METROPOLITAN AREA PLANNING
DEPARTMENT

Re: S/D 90-48 - (Final Plat) Cedar Meadows Addition

CEDAR MEADOWS ADDITION

STAFF COMMENTS:

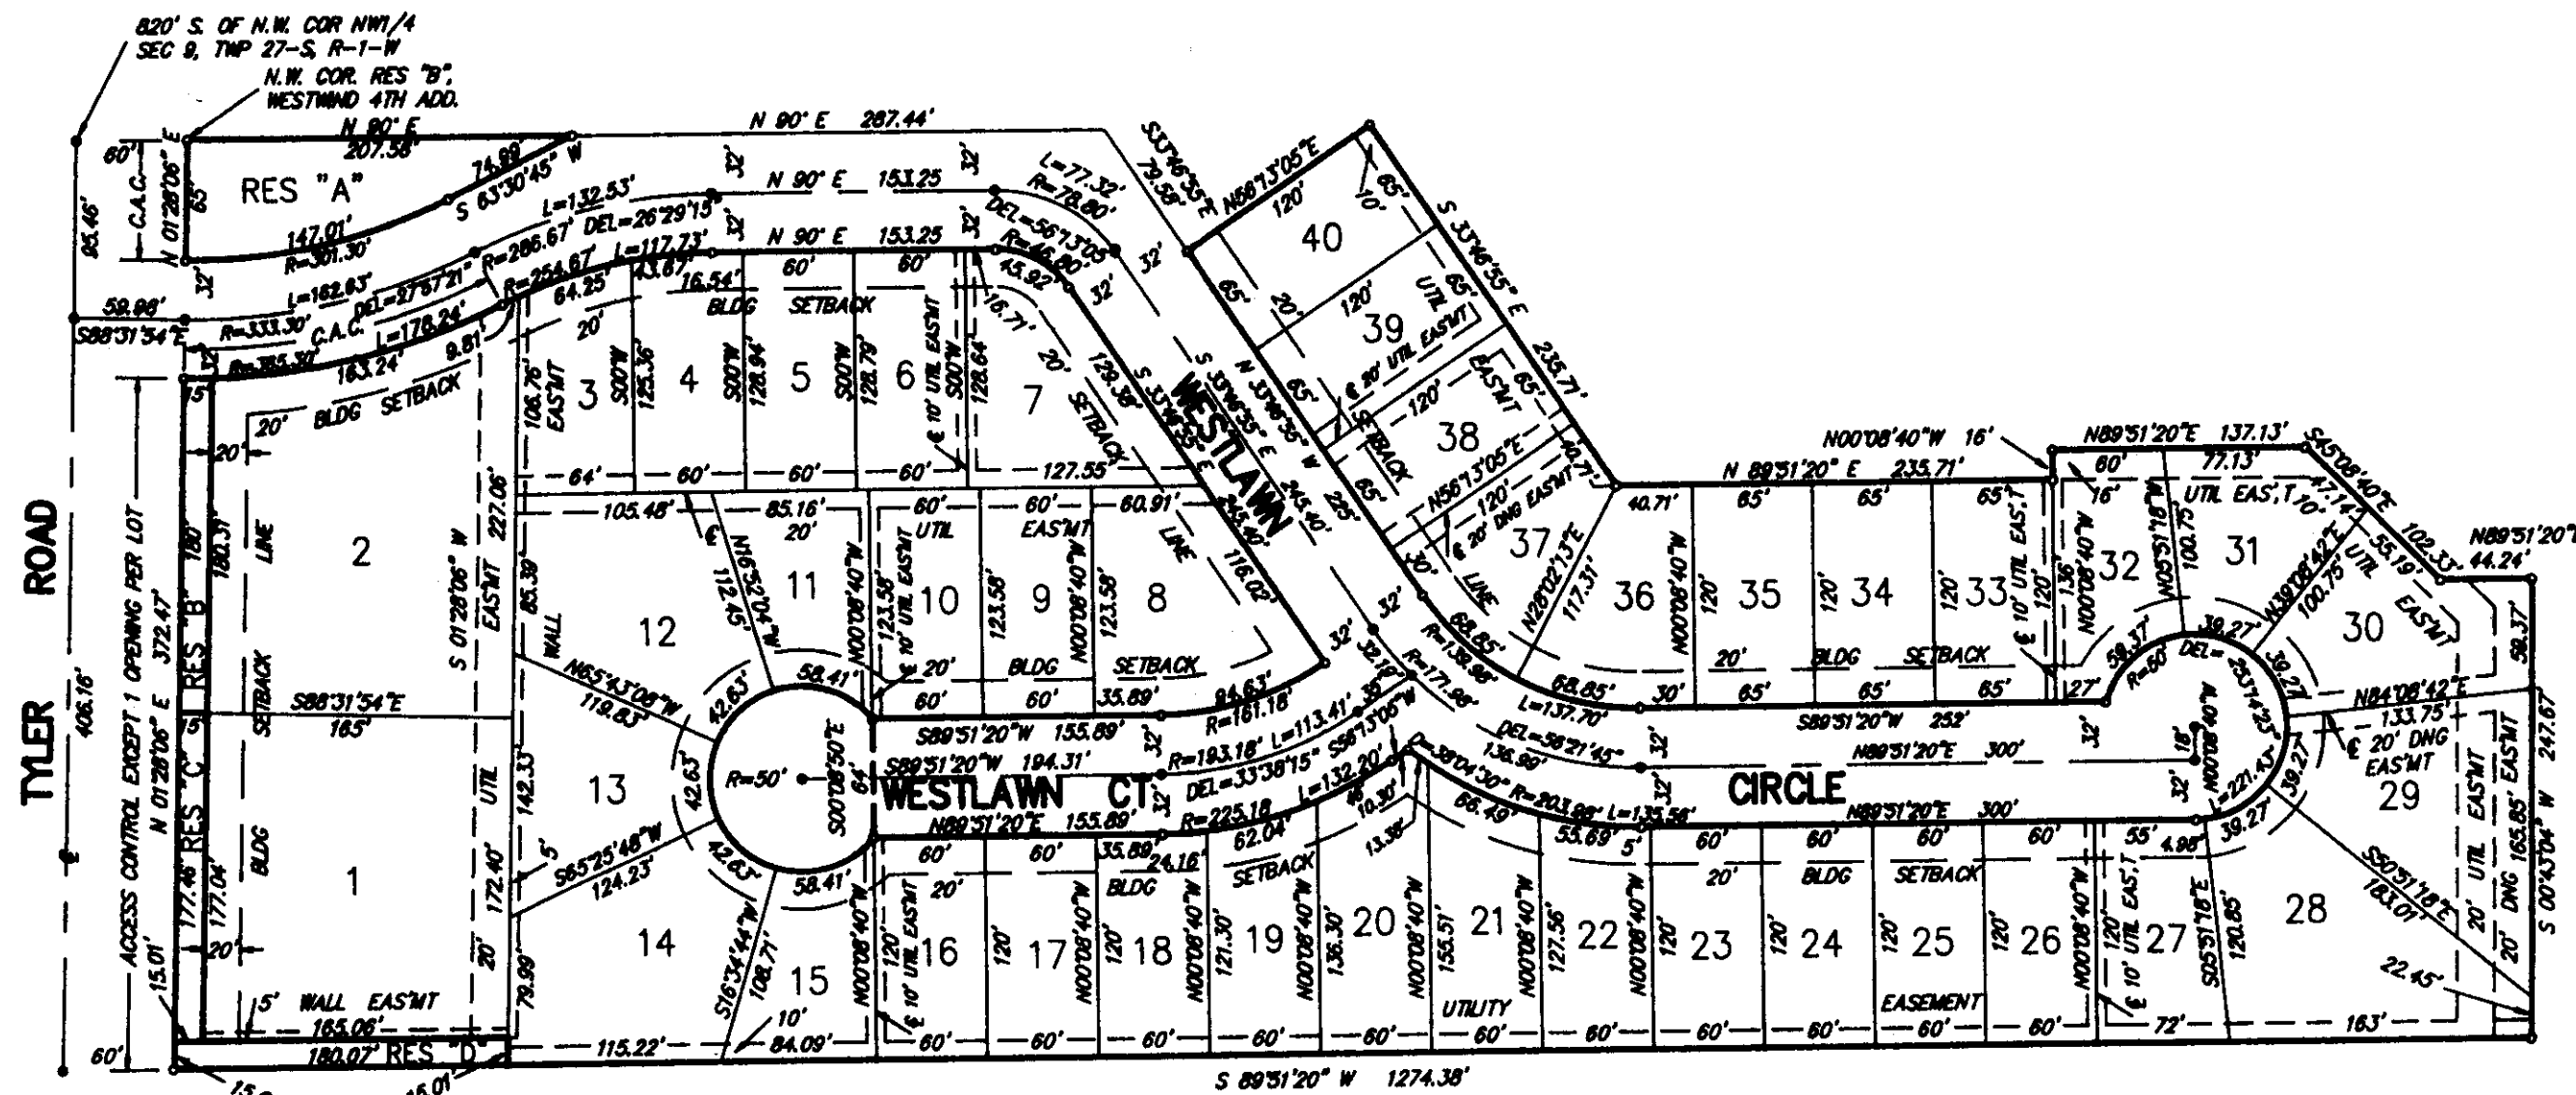
On the final plat, as indicated in the CUP for 64-foot street rights-of-way, 25-foot building setbacks shall be indicated as the front yard setback for all residential lots.

On the face of the plat and in the plat's text, it shall be indicated if the minimum building pad elevations refer to the minimum floor or opening level.

On the final plat tracing, the following revisions shall be made to the plat's text:

~~Line 3 shall be revised to indicate "platted into Lots, Reserves and streets. . ."~~

~~The reference to the Westlawn Court Cul-De-Sac being dedicated, noted in the lower section of the text should accordingly be deleted and replaced with the standard reference of "The streets are hereby dedicated to and for the use of the public."~~

~~On line five, the word reserved has been repeated and needs to be corrected.~~

~~Reserve D shall also be indicated as intended for "the preservation of the existing row of trees."~~

~~In regard to the location of openings being allowed in the areas of access control it shall be indicated that the City Engineer is to approve the location of any such openings.~~

~~I. As requested by KG&E, the final plat tracing shall indicate a 10-foot utility easement along Lot 30 and 38's common lot line and between Reserve B & C's and Lots 1 and 2's common lot lines.~~

~~As indicated by this site's drainage plan, off-site drainage easements shall be provided for this plat. These easements shall be provided to Engineering for approval and to Planning for recording with the plat's approval.~~

~~N. Perimeter closure computations shall be submitted with the final plat tracing. Section 5-101(c).~~
